# UNITED STATES PATENT AND TRADEMARK OFFICE

10/588,387

<b>Office Action Summary</b>	<b>Application No.</b> 10/588,387	<b>Applicant(s)</b> ZENOBI, MAURO	
	<b>Examiner</b> Daniel C. Comings	<b>Art Unit</b> 3744

## **DETAILED ACTION**

Fig. 1

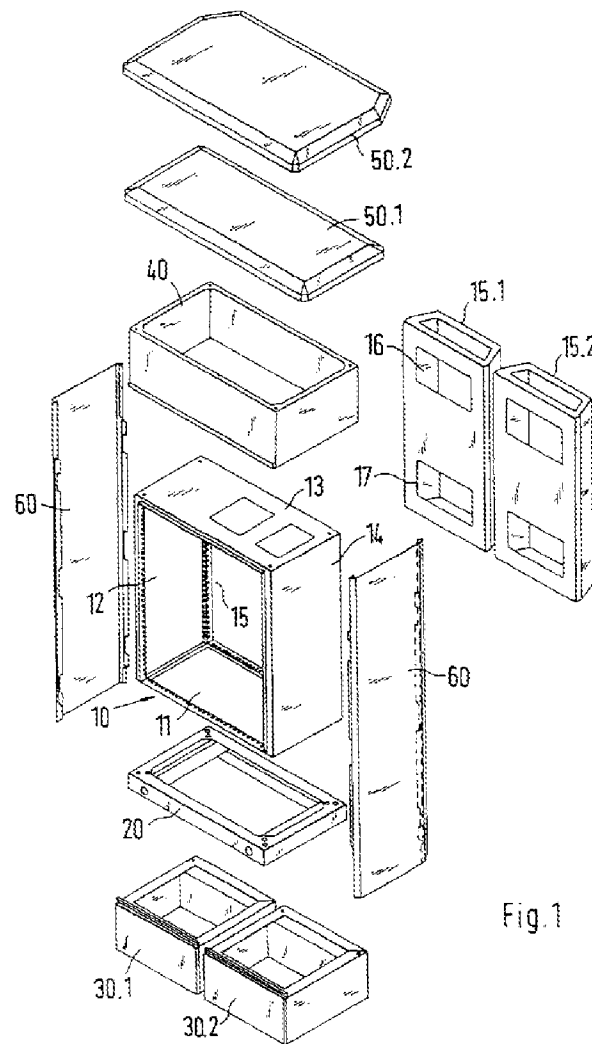
Scheuer does not teach the presence of a separate compartment for the cooling and processing systems. The inclusion of a separate compartment in a refrigeration device is well known in the art as illustrated by Strackbein. Strackbein teaches in fig. 1 shown on pg. 9 of this action, a modular housing for a refrigeration device having refrigeration components (15.3) (embodied as an air conditioner) arranged in compartments separate from the compartment to be refrigerated (within body 10) and also an additional air conditioner 40.1 (not shown in fig. 1) in the separate roof housing (40). It would have been obvious to one of ordinary skill in the art at the time the invention was made to modify Scheuer with the separate machinery compartment of

Scheuer teaches limitations from claim 18, an apparatus according to claim 12 wherein the processing system comprises a sub-system for thermal control of the refrigerated space (teaches a programmable controller for the cooling system being located in cabinet 20 in fig. 1, shown above, in the second to last paragraph on pg. 3), said sub-system being independent of, but in communication with, the processing system (the cabinet 20 is shown to be in communication with the computer at 22 but no control by the computer is disclosed.)

**Fig. 2x**

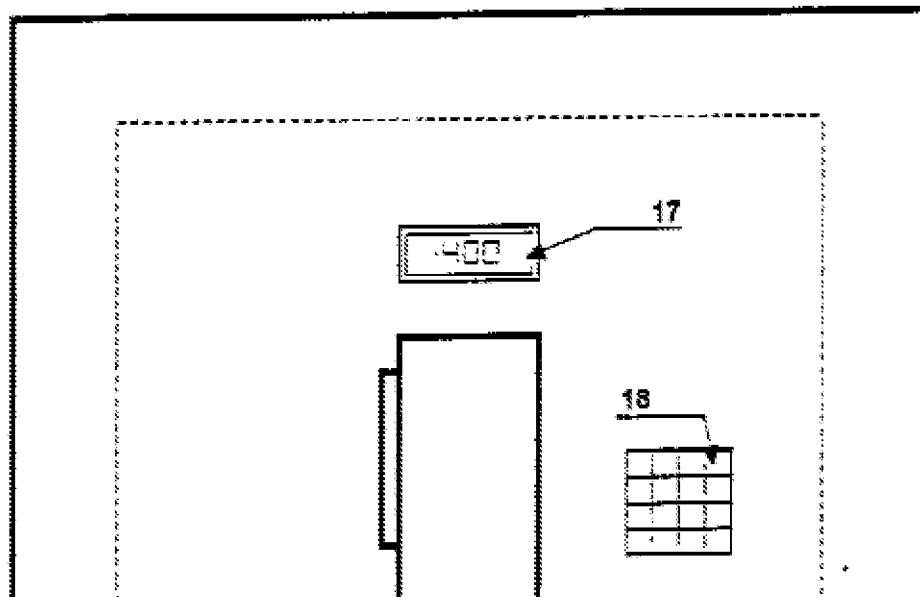
Scheuer teaches limitations from claim 13, an apparatus according to claim 12 wherein the processing system is capable of controlling the receiving, preservation and supply (Scheuer's invention is taught for receiving, preserving (by cooling) and dispensing units of blood in the Abstract) of the bags and is connected to a keyboard (in the last paragraph of pg. 1) and a screen (in the first paragraph of pg. 1), both placed at the walls of the cabinet (as shown above in fig. 2x, a section of Scheuer's fig. 2, enlarged by examiner.)

Fig. 3

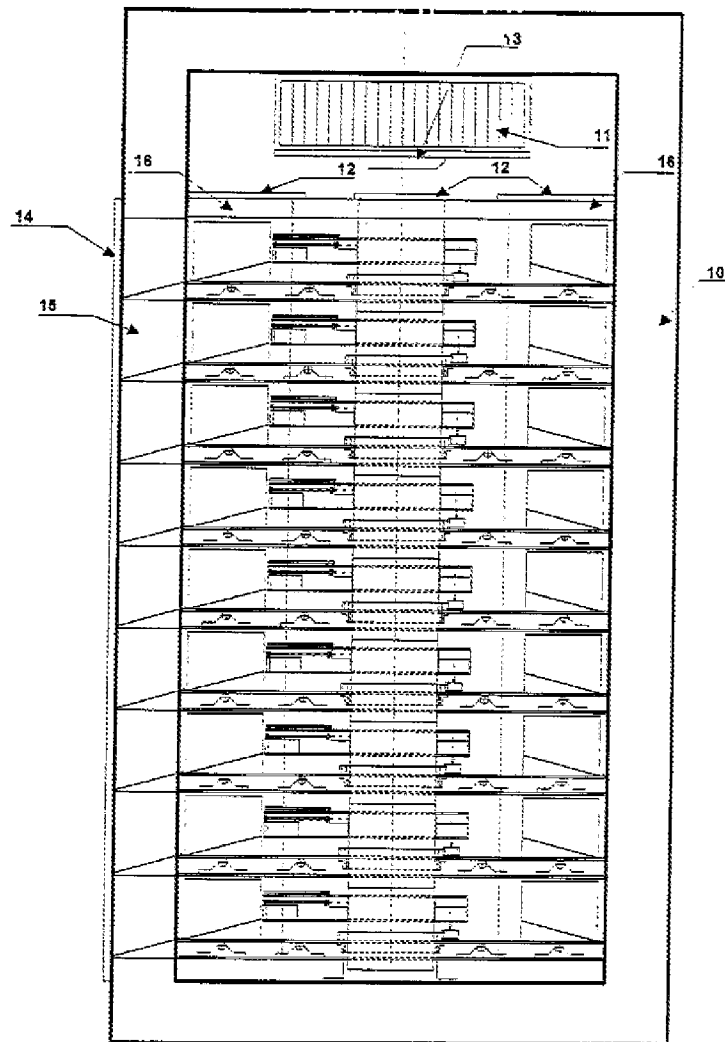
Scheuer teaches limitations from claim 17 in fig. 3, shown above, an apparatus according to claim 12 comprising only one door (14) which extends from the first to the last level of the magazine (as shown) and wherein the movement system is capable of rotating a single level at a time (Scheuer teaches in the second paragraph of pg. 3 that the turntables are capable of turning in different directions from one another, thus implicitly teaching that they can be independently controlled.)

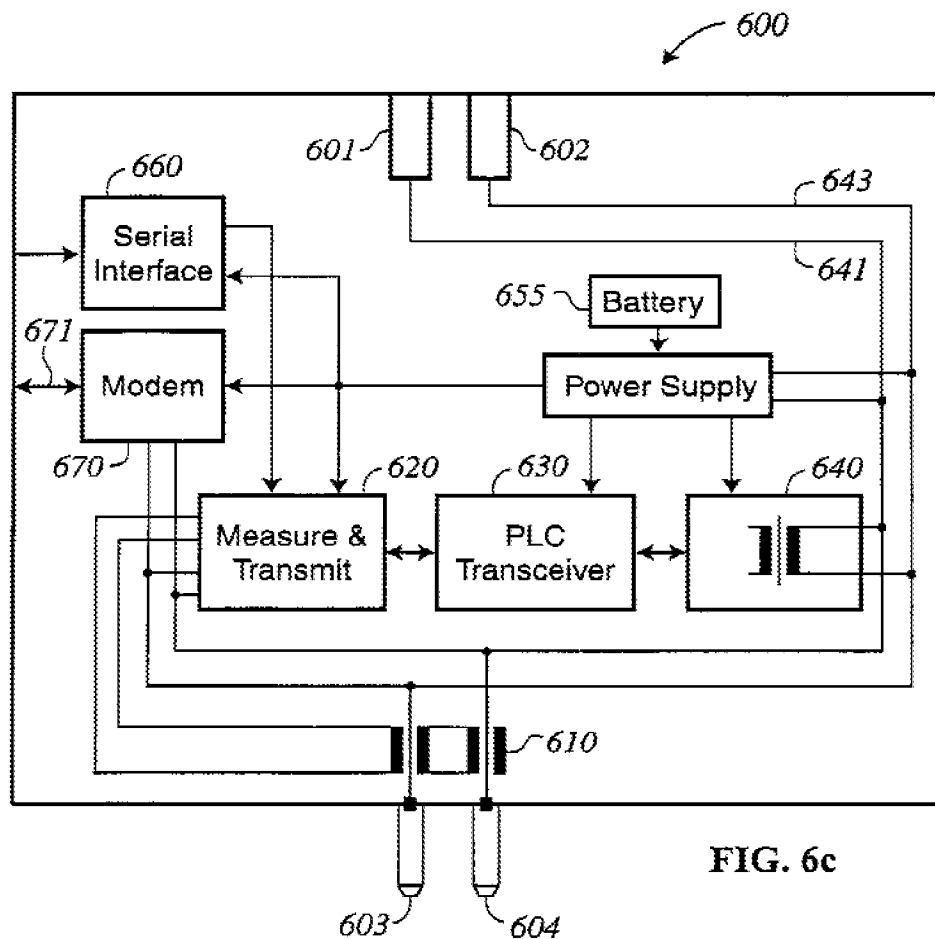
Regarding claims 15 and 16, Scheuer does not teach the system having a wireless network port or wireless modem. The use of such wireless connection components is well known in the art as illustrated by Sharood. Sharood teaches in fig. 6c, shown above, a system for remotely monitoring a refrigeration system, the monitoring system having a modem (670) taught in lines 40-45 of col. 10 to optionally be wireless. One of ordinary skill in the art at the time the invention was made would
